## **[NOTICE] Terminal Plating Change**

### **1. Change Item : Terminal plating (Sn-Bi to Pure-Sn)**

# Engineering Change Notice of Pure-Sn plating for QFP

Package : QFP

Solder ability1 Steam aging	Solder ability2 High temp storage
Photo after solder dipping

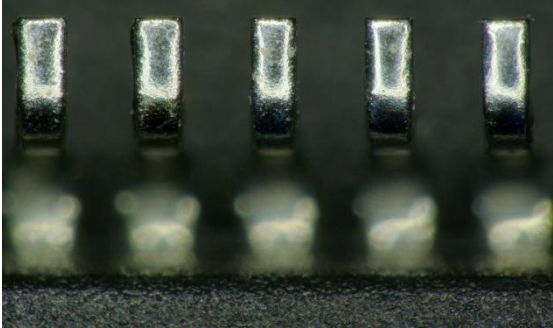
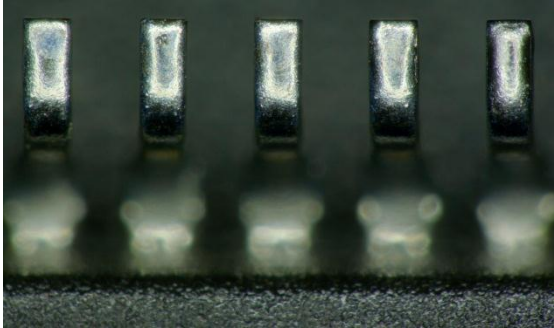
## ■ Solder ability1

Steam aging : 4hrs  
Flux dipping time : 5~10sec  
Solder temp. : 245°C  
Solder dipping time : 5sec

## ■ Solder ability2

High temp. storage : 150°C 16hrs  
Flux dipping time : 5~10sec  
Solder temp. : 245°C  
Solder dipping time : 5sec

Pass. All terminal solder wets rate more than 95%

## ■ Criteria

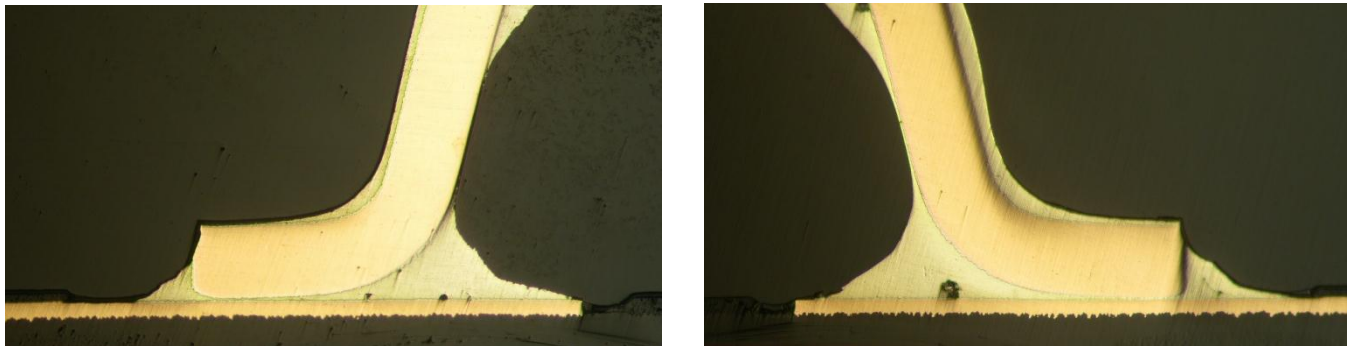
Solder wet rate more than 95%

<Representative photo after 1000 cycle >

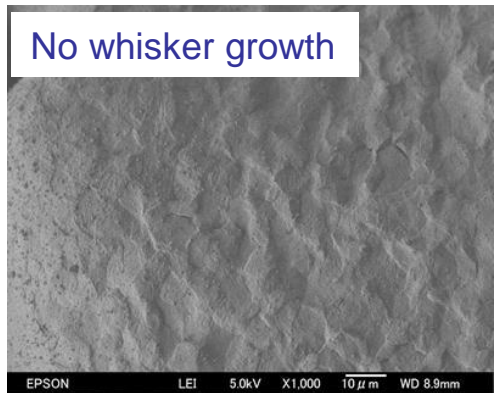
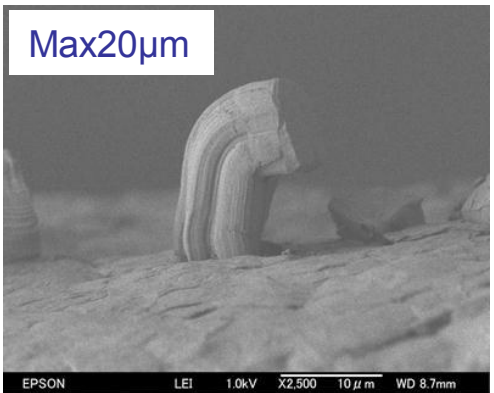
- Sample : P-LQFP048-0707-0.50(QFP12-48Pin) N=10
- Board spec.
  - Dimension : 100mm × 100mm t = 1.6mm
  - Material : FR-4
  - Layer count : 1 layer( One side board )
  - Cu layer : 35μm
  - Surface processing : Water-soluble pre-flux processing
- Solder paste : Sn-3.0Ag-0.5Cu
- Test condition : -40°C ⇔ 125°C (each 30 minute)
- Judgment criteria : A conduction part being left in the section part by section observation
- Test result : Pass. Because a conduction part is left in the section part after 1000cycle
